SERVICE DIRECTIVE BULLETIN NO. 0092

Revision 4

DATE: October 21, 2025

1. SUBJECT: Fuel Quantity System Calibration
2. MODEL: F-28A, F-28C, F-28C-2, F-28C-2R, 280, and 280C
3. EFFECTIVITY: All Serial Numbers
4. BACKGROUND:

FIGURE 1. FUEL TRANSMITTER

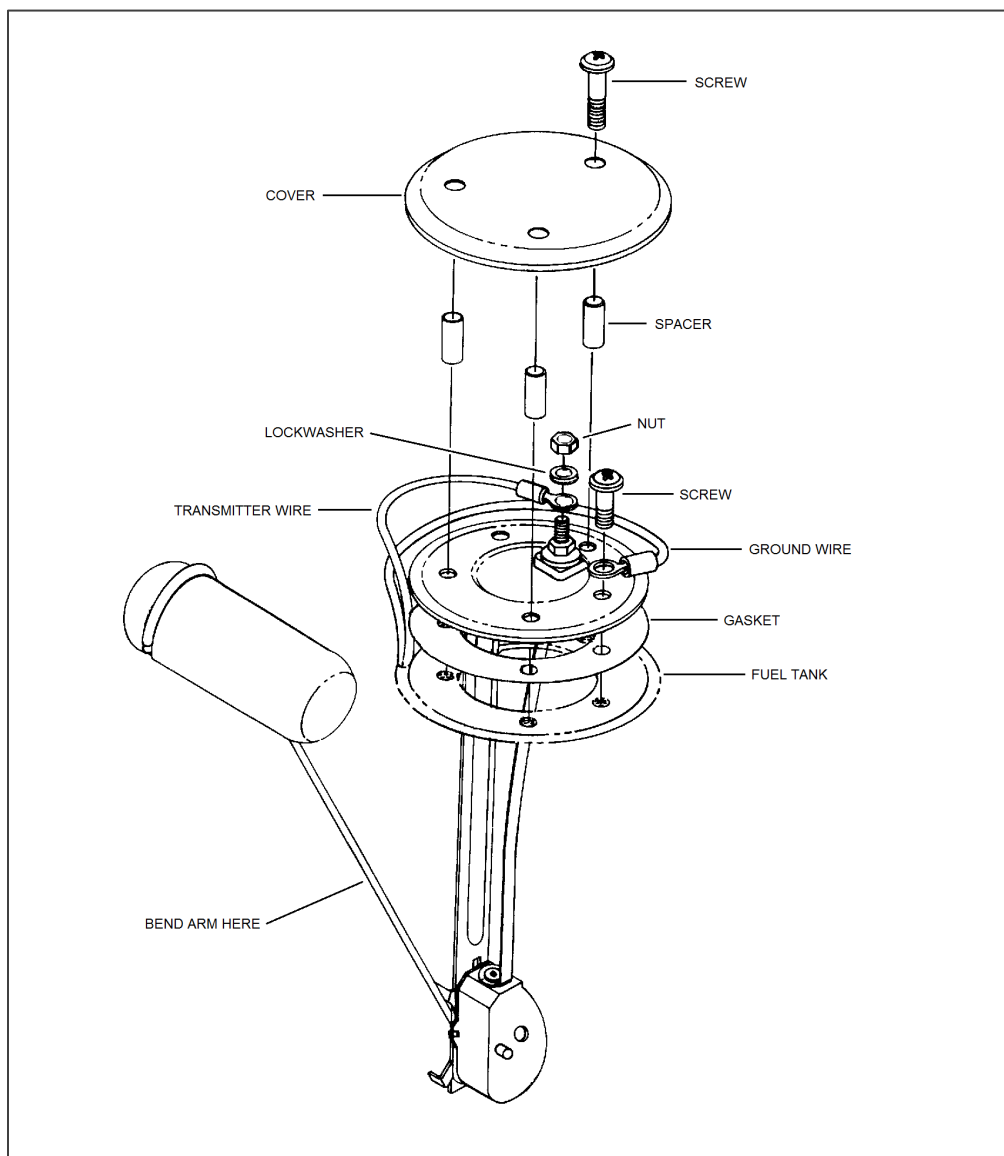
5. Turn the Master Switch "ON" and check that the fuel quantity indicator is at "0". If the indicator is not at "0", turn the Master Switch "OFF". Disconnect the wiring from the fuel transmitter and remove the transmitter from the tank in accordance with paragraph 5.3. Bend the float arm down at the approximate midpoint if the indicator is below "0", bend the float arm up at the approximate midpoint if the indicator is above "0" (See Figure 1). Reinstall the transmitter and check the "0" indication. Repeat the adjustment procedure as required.

In the following checks, the location of the bend in the transmitter arm can be moved to adjust the indicator range movement. If the zero fuel indication is "0" and the "1/4" or "60" indication is high, move the location of the bend in the arm closer to the arm pivot. If the indication is low, move the bend location closer to the arm float. After making an adjustment to the bend in the arm, always recheck the zero fuel condition. The indicator must indicate "0" when the aircraft is in the zero fuel condition.
